36° 300 M. TANK & TOWER

ORONO MINN.

WELDING SCHEDULE

DRAWING NO *E-5*

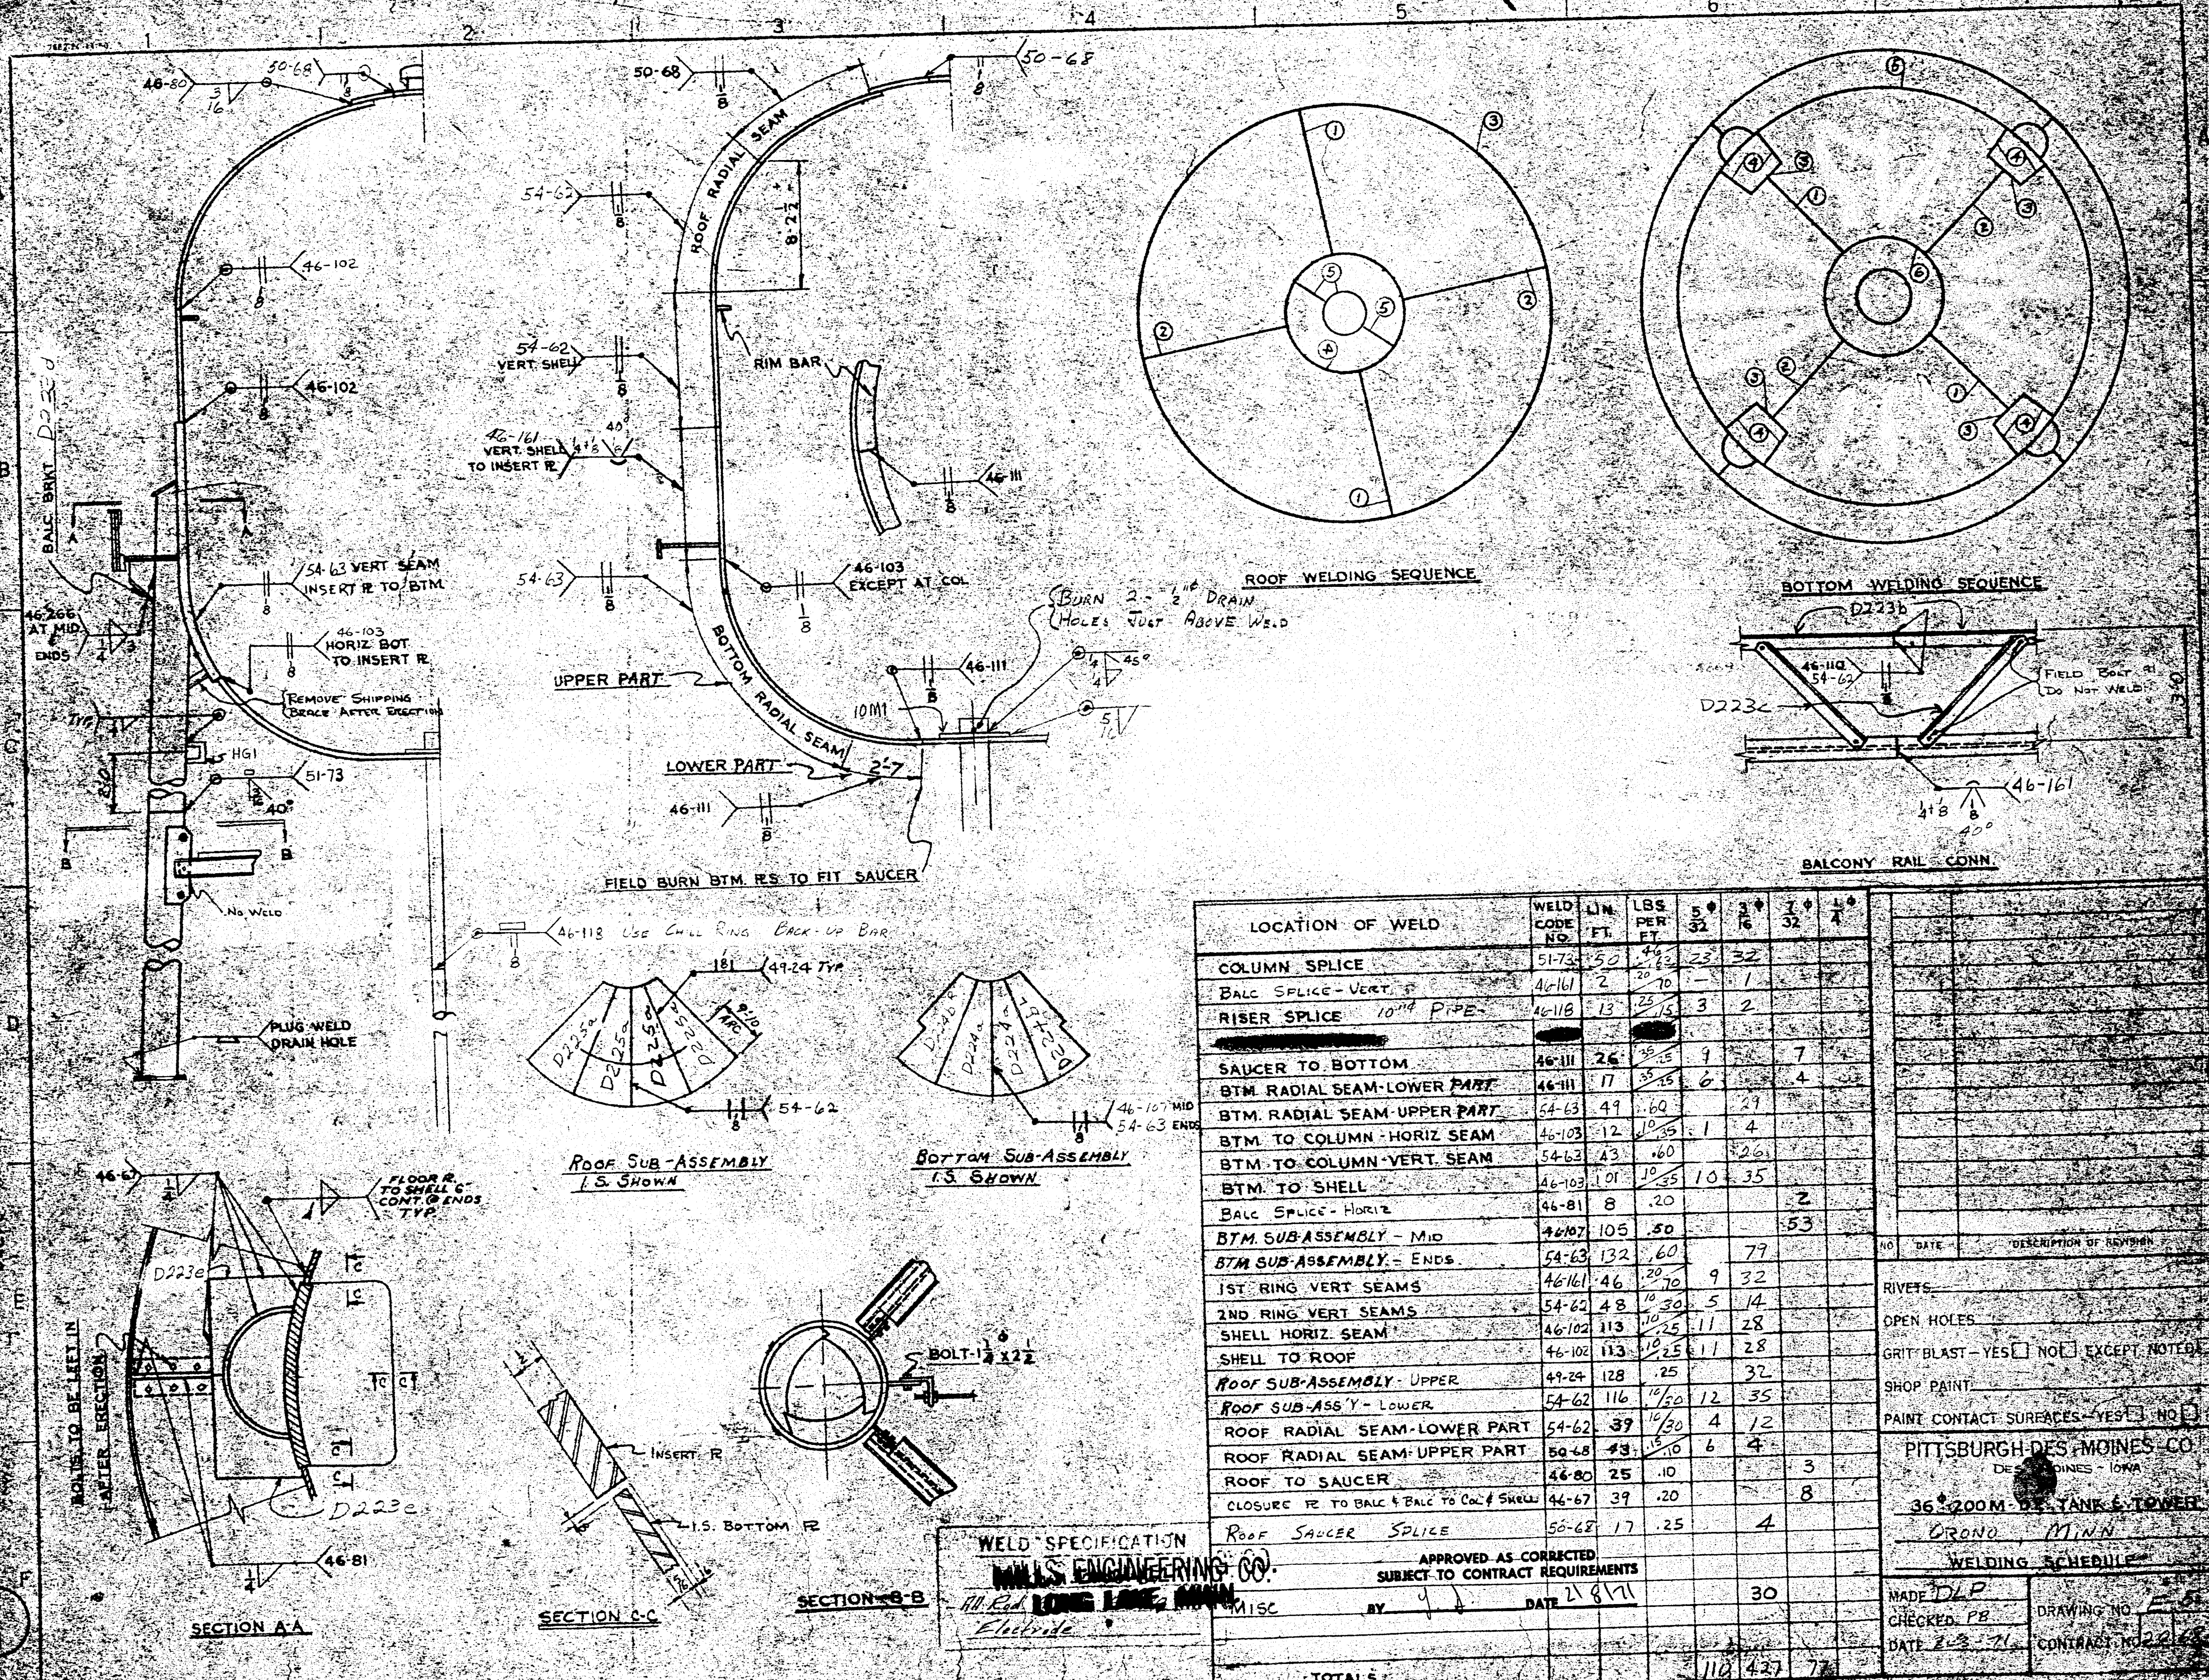
APPROVED AS CORRECTED
SUBJECT TO CONTRACT REQUIREMENTS
BY *Y* DATE *2/8/71*
